Technical change to module RS DIN C 64S LP2N

PCN-number: 20230926
This document has indefinite validity from today

RS Interface product (w/ LP2N
and flat connector)

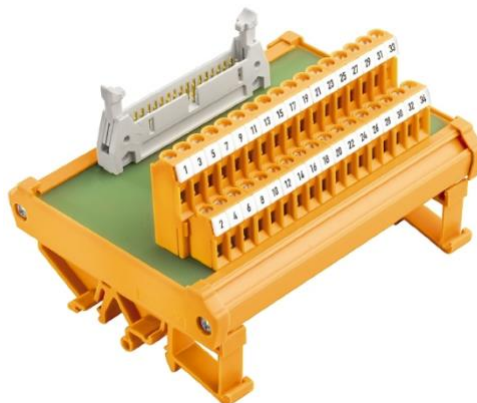
Article on Section 5 was delivered in the past with LP2N connectors. In addition, it was delivered with Dekafix*

Based on continuous improvement, the LP2N connector will be respectively replaced by LL2N connectors.
Furthermore, all the connectors will be marked with KSW strip markers.
